Proposed Residential Development, Land North of Hobbyhorse Lane, Sutton Courtenay, Oxfordshire

Review of the Sutton Courtenay Flood Risk Assessment produced by JNP Group on Behalf of Redrow Homes

**February 2016
Version 4: Final Report**

Figure 1. The topography of the area surrounding the development site (red outline) with levels ranging from 47.5m AOD (green) to 62.9m AOD (red), with 1m contours is grey. (Source: EA 1m resolution filtered LiDAR, scale 1:5,000)

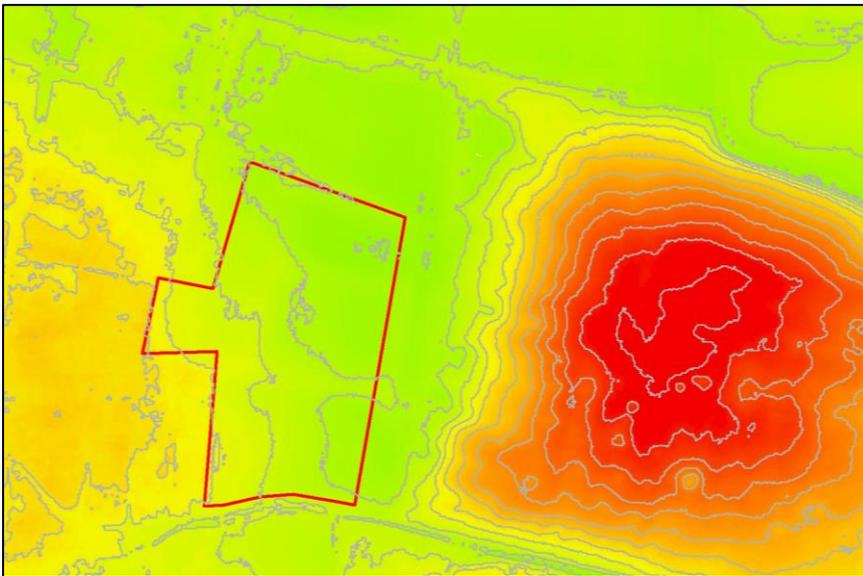
The description of the site is rather brief and in particular there are no ground-level or aerial photographs showing the development site in its current state. The topographic survey as presented in Appendix A is poorly presented, with large scale maps showing spot heights plotted over 8 pages and largely illegible at the normal A4 page size. Only one of these pages shows any contours and there is no overview map showing the topography of the site in relation to the surrounding areas. Generating a digital terrain model from the topographic survey and displaying this as a shade colour-ramp image would give a better presentation of

the topography (Figure 1). The description misses the fact that the site is considerably lower than the existing residential land to the west and the capped landfill to the east. The fact that the site is considerably lower than the surrounding areas has implications in terms of the flood risk for the site receiving surface water and being at risk of flooding from high groundwater.

Figure 2. Surface water flood risk map showing areas within the development site (highlighted).

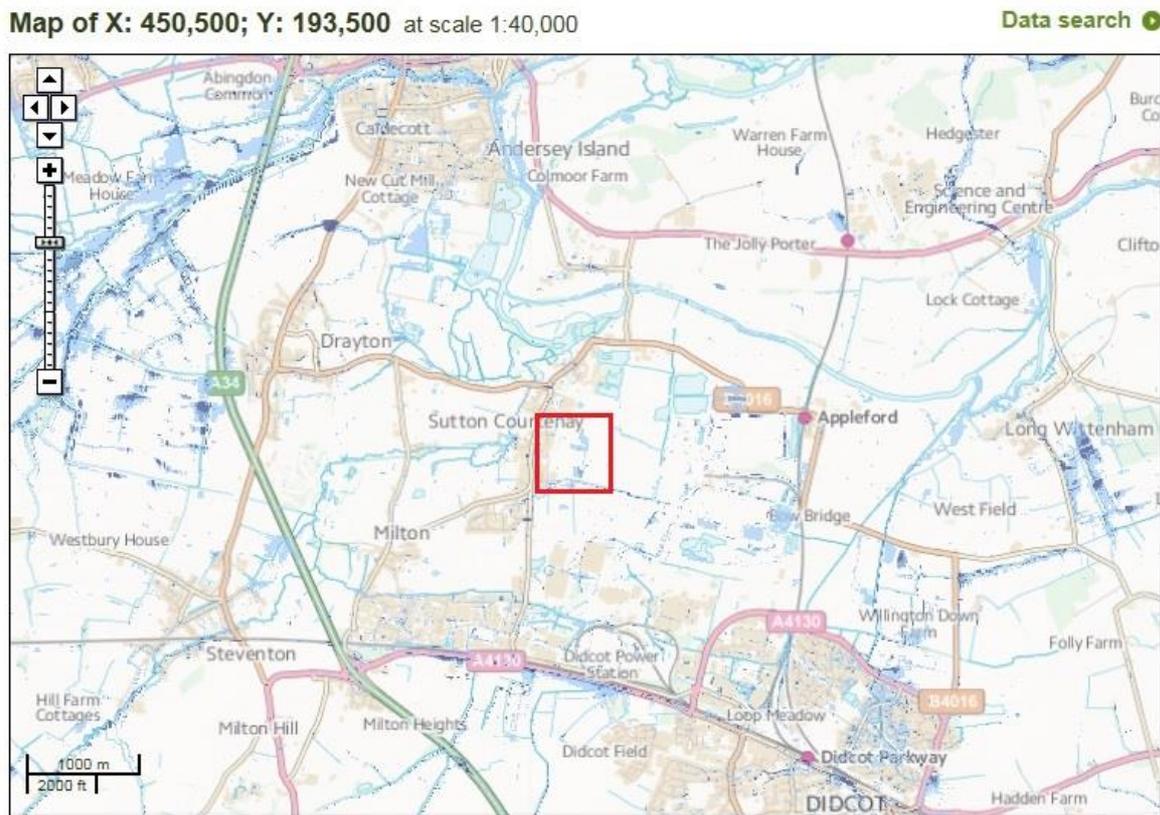
Critically the EA surface water flood risk map is not included as this shows a medium and high risk of surface water flooding over parts of the site (Figure 2). Also recent incidents of flooding of the site were observed in 2012 and again in 2014 (Figure 3). Furthermore the description of the hydrology identifies ditches along the northern and southern boundary of the site but neglects the presence of a ditch along the eastern boundary at the foot of the landfill. This ditch was also observed to be full and overtopping into the site in December 2012 (Figure 4). No further information has been provided about the catchment of these ditches nor have any assessments been made of the potential flood flows in the ditches and possible impacts on the site. In addition the recreation ground immediately to the north of the site is prone to flooding with water emanating from the upslope development site (Figure 5). The FRA does not give any detail on the how water from the development site can affect neighbouring areas.
